Burlington Development Review Board

Tuesday, August 2, 2022, 5:00 PM

To: Development Review Board
From: Mary O'Neil, AICP, Principal Planner
Date: August 2, 2022
RE: ZP-22-398; 79 Pine Street

Request: Alternative Compliance for rooftop screening, required by Condition #22 of ZP21-118OG / ZP21-0927CA, ***“Rooftop mechanicals shall be screened.”***

PINE & BANK w/ screen

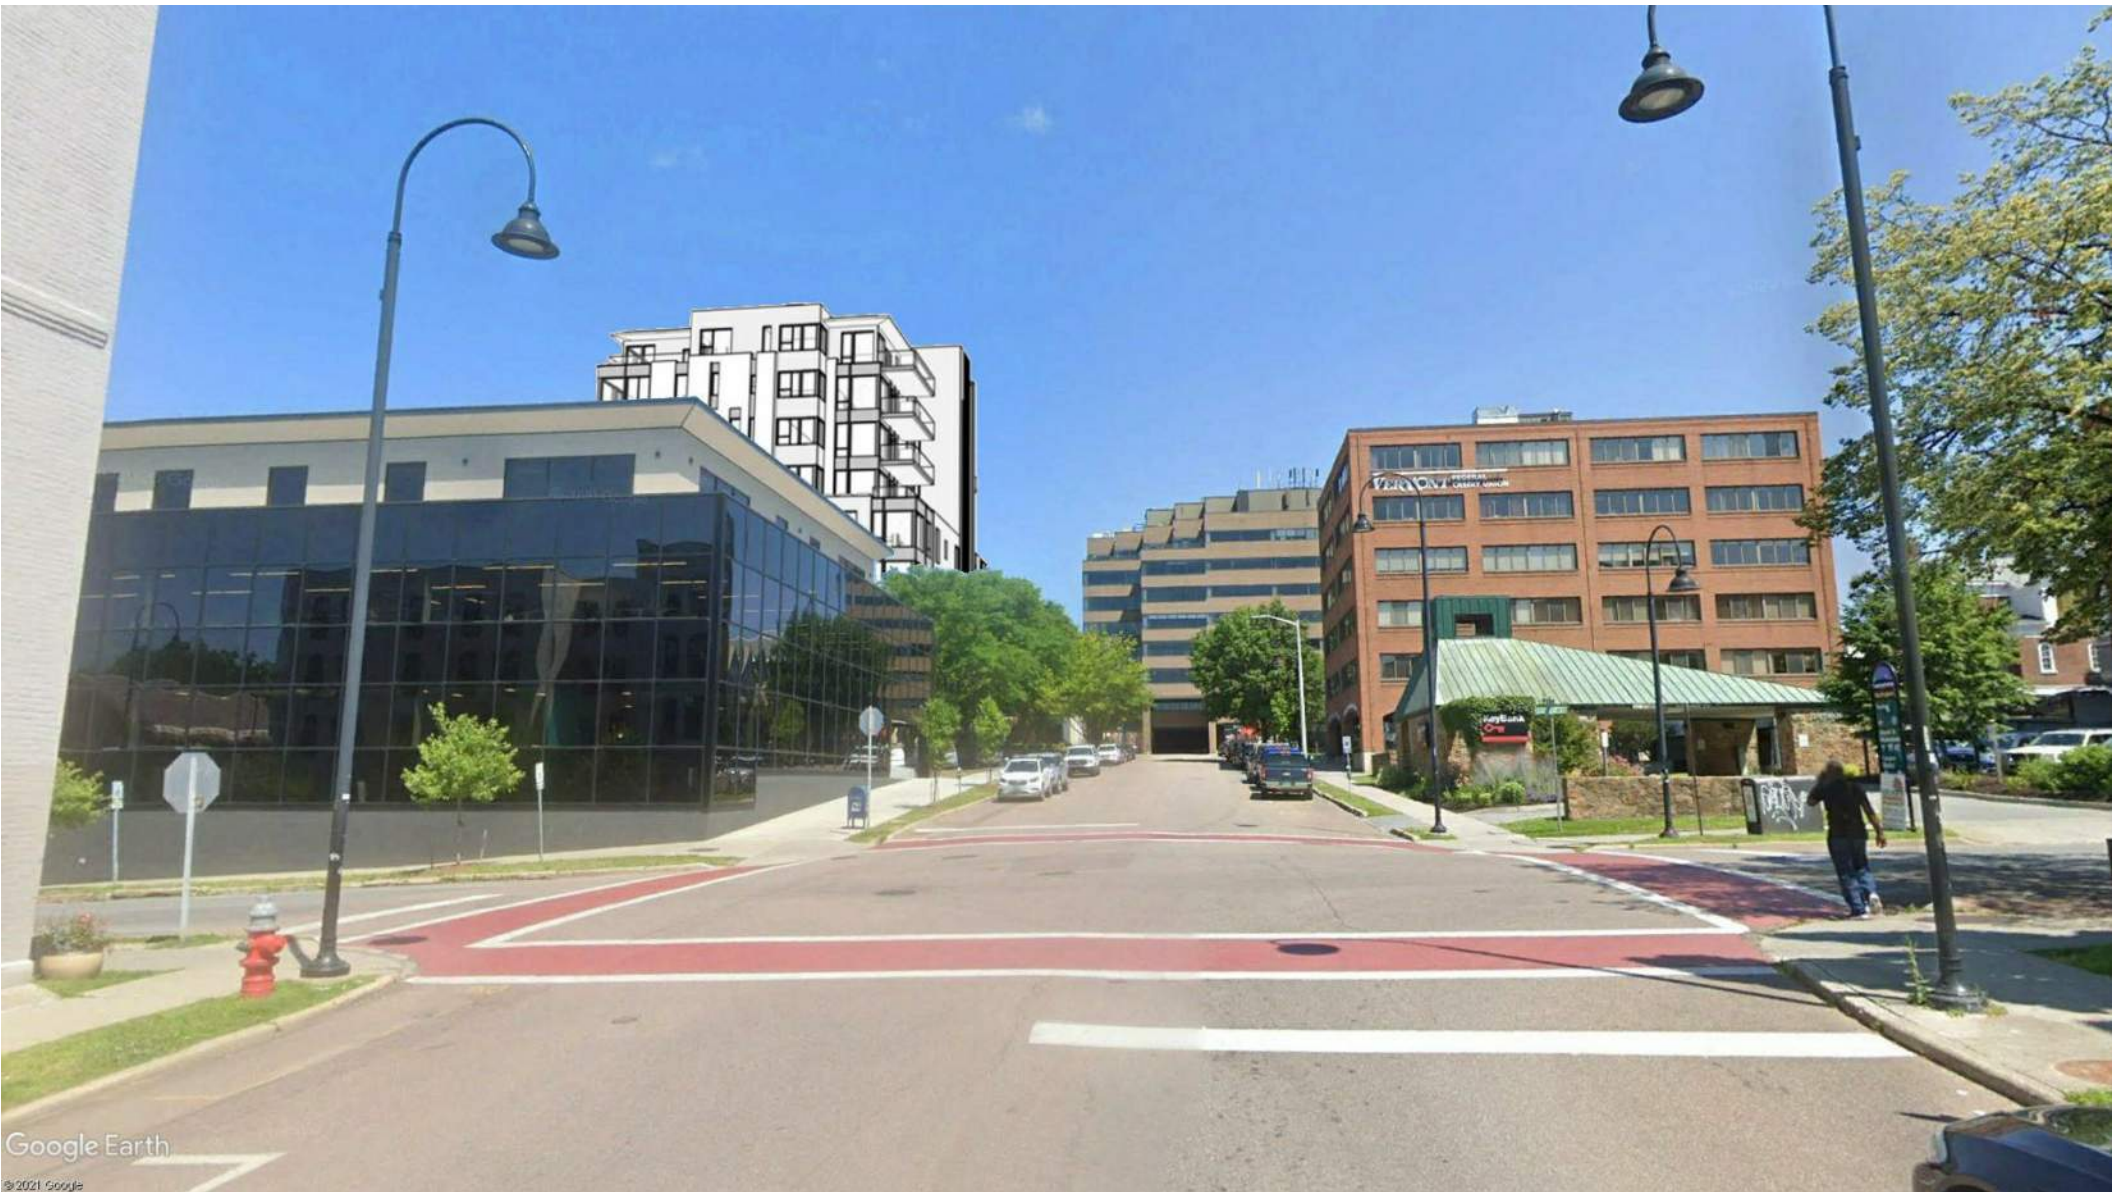
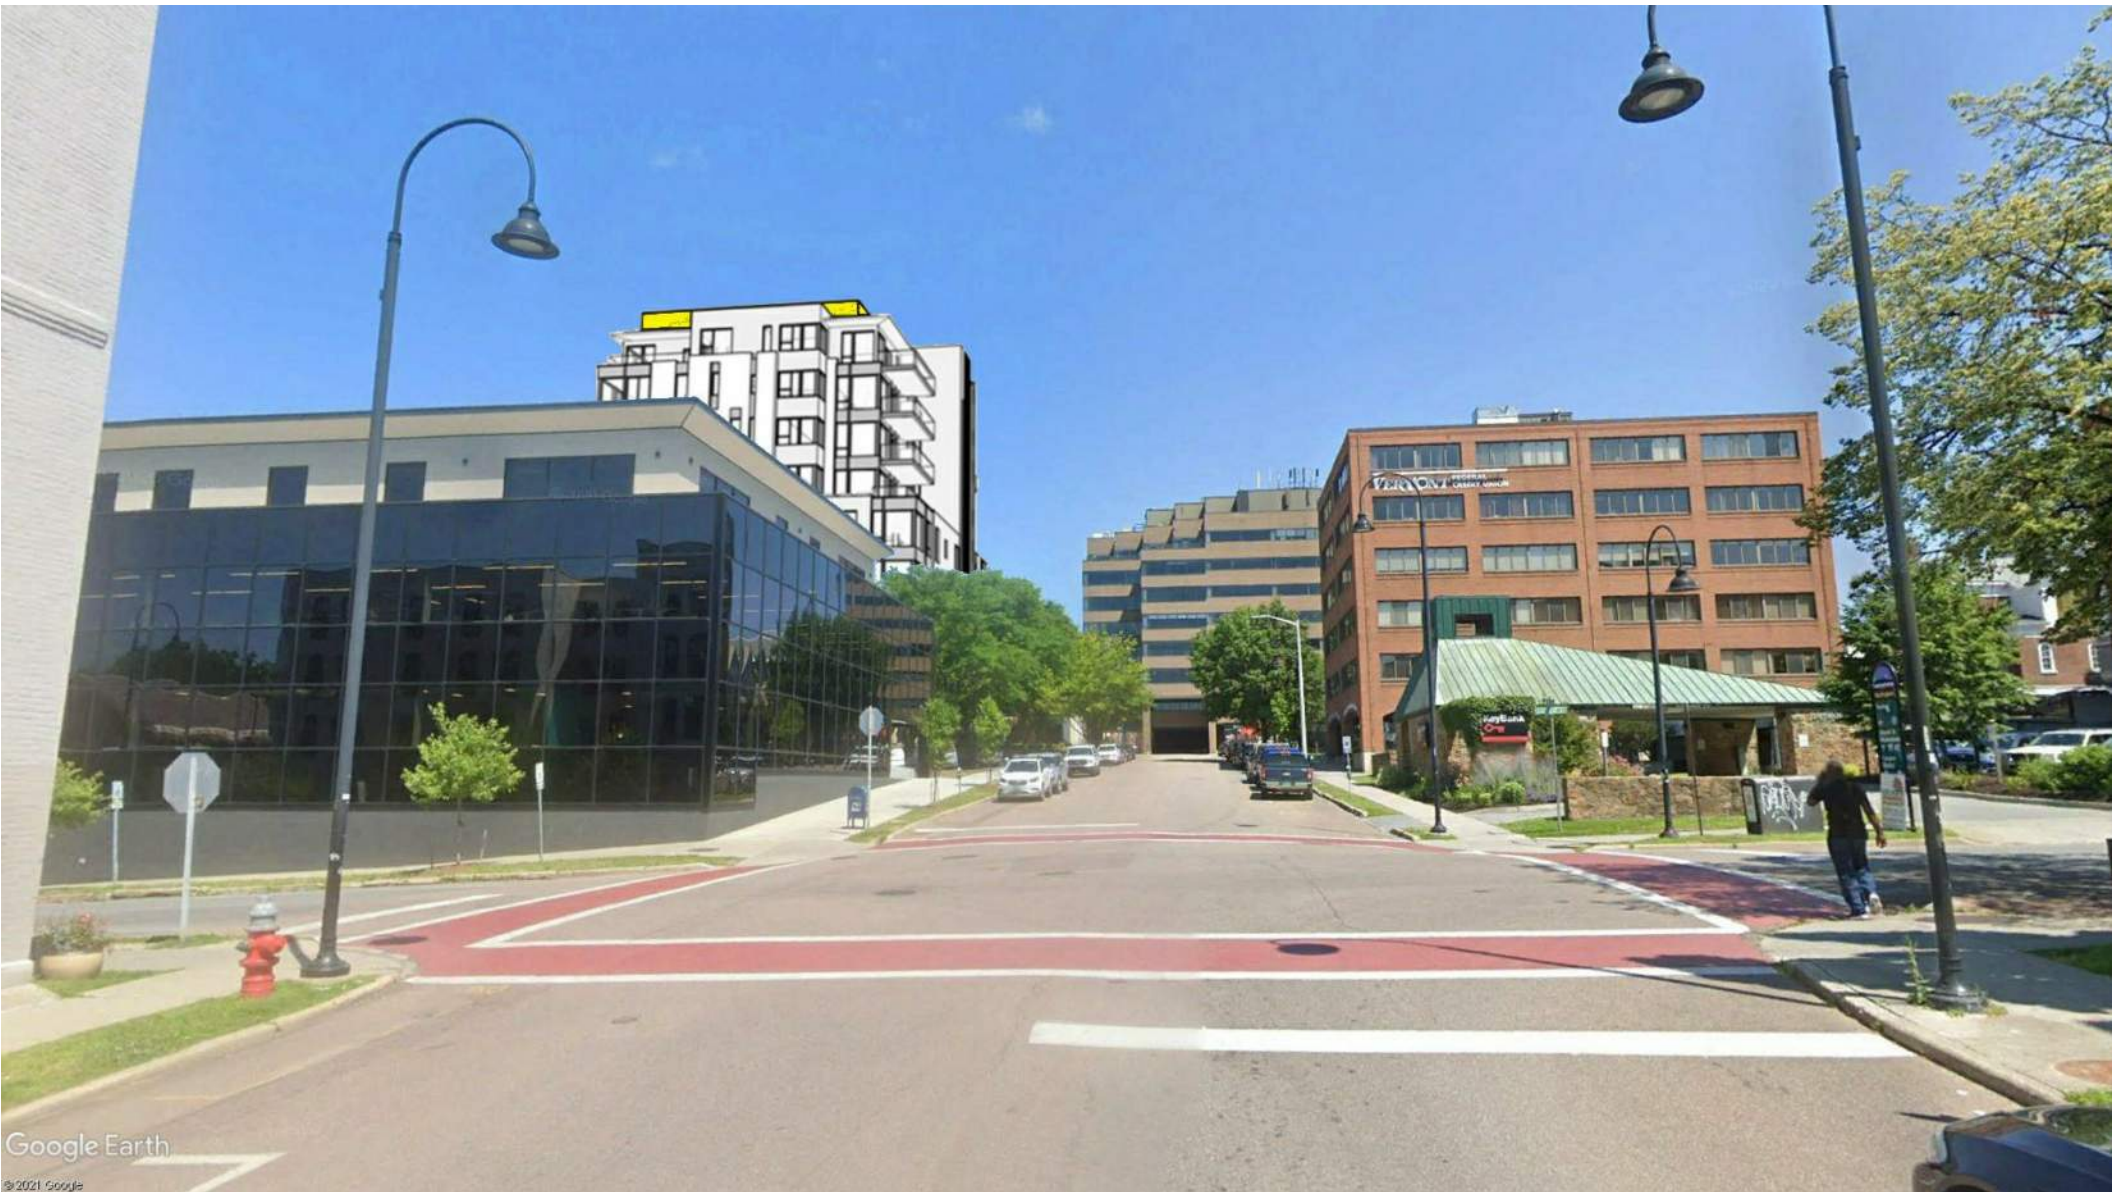
Reference is made to the submitted roof plan, and additional examples of images and photo.

ROOF SCREEN VISIBLE (YELLOW)

COLLEGE ST. GARAGE w/o screen

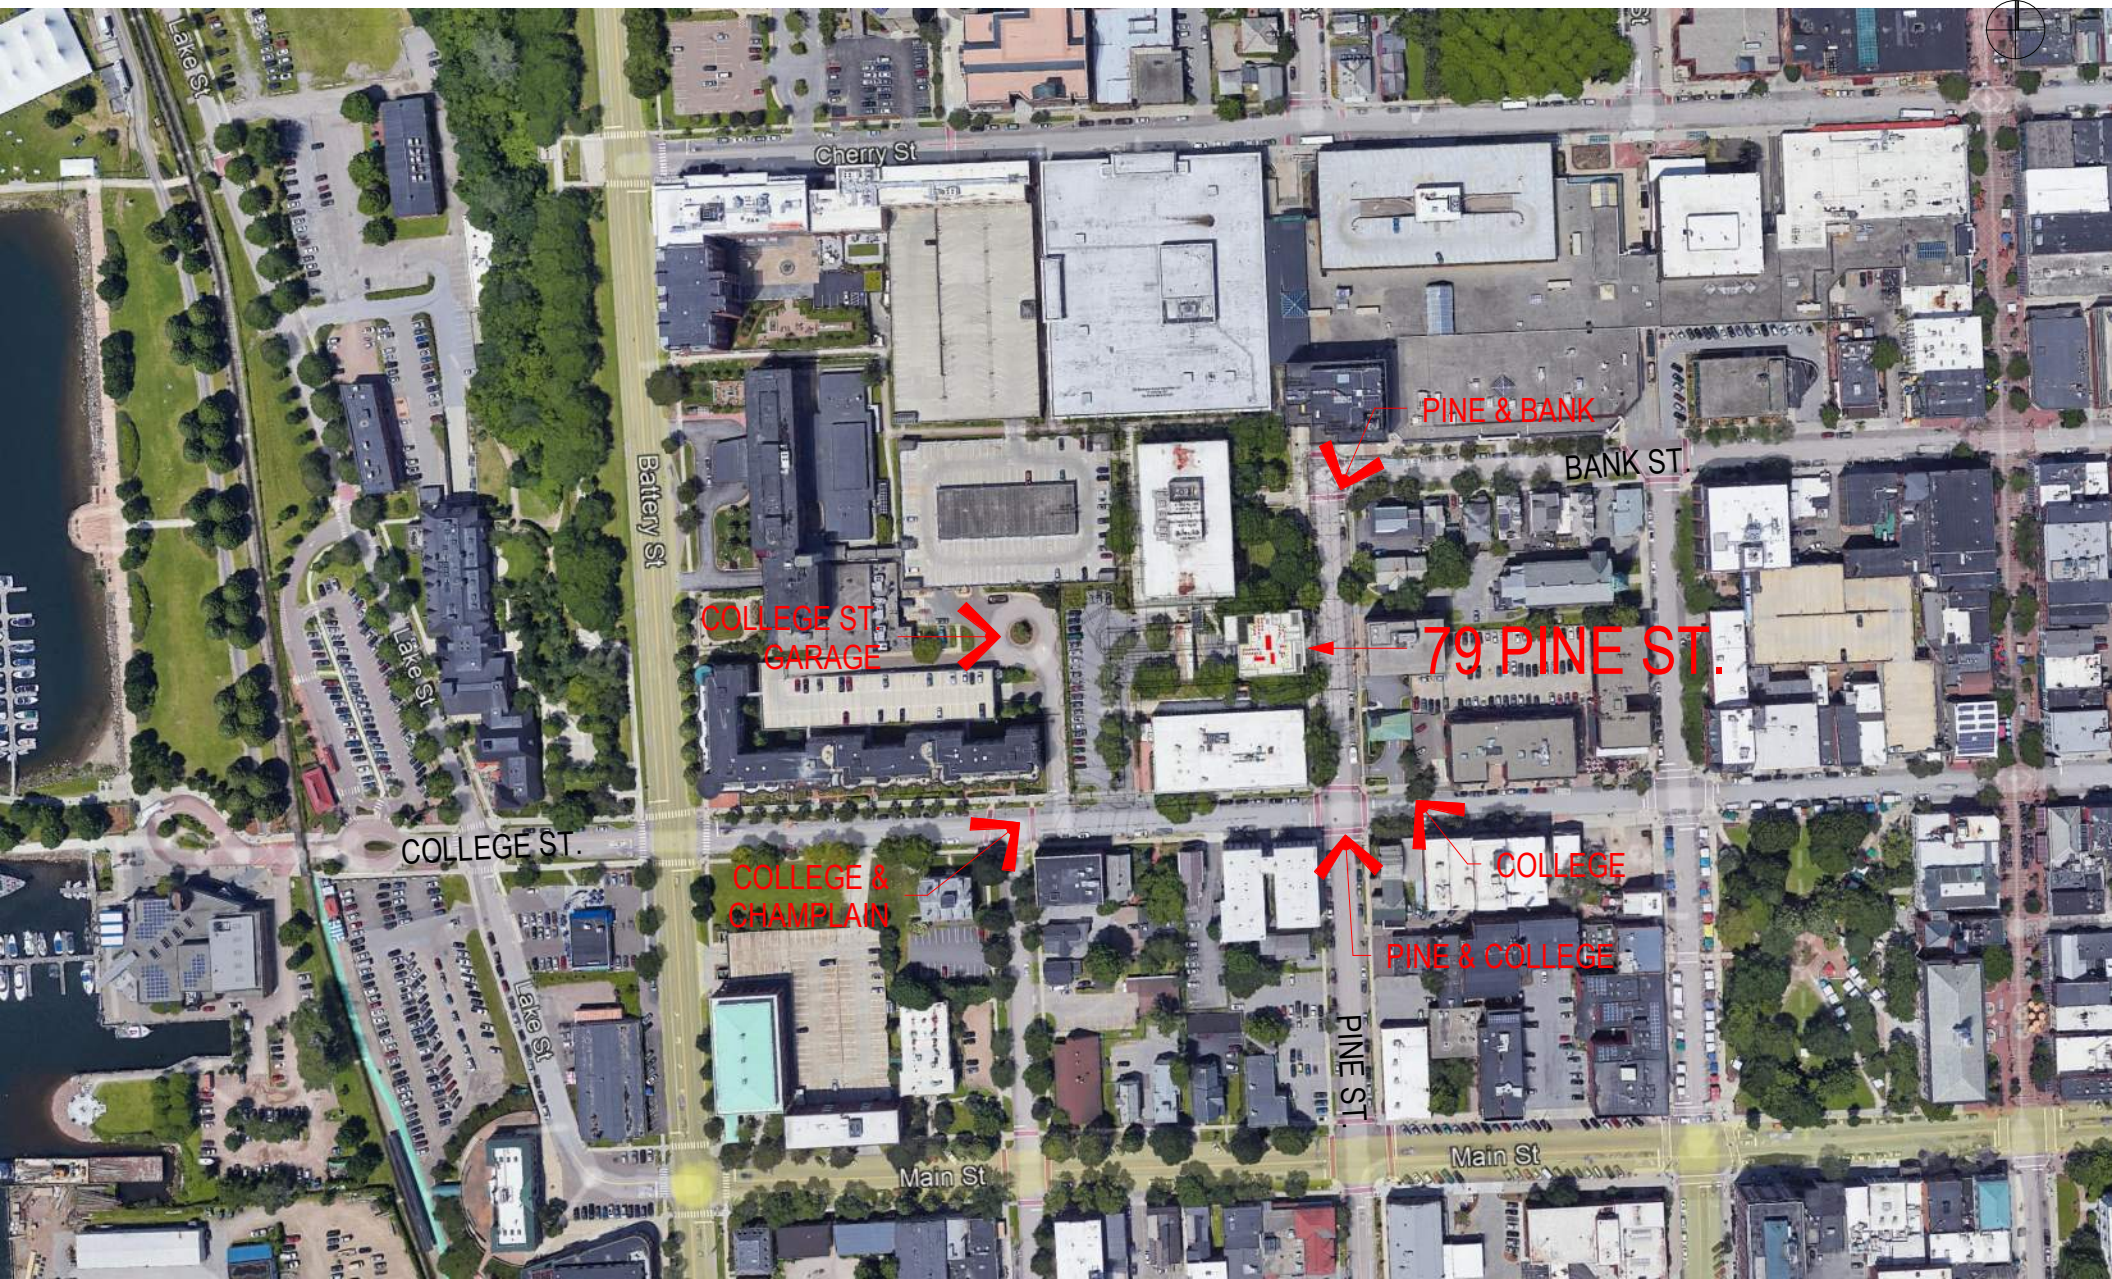
NO ROOF EQUIP. VISIBLE

ROOF SCREEN VISIBLE (YELLOW)
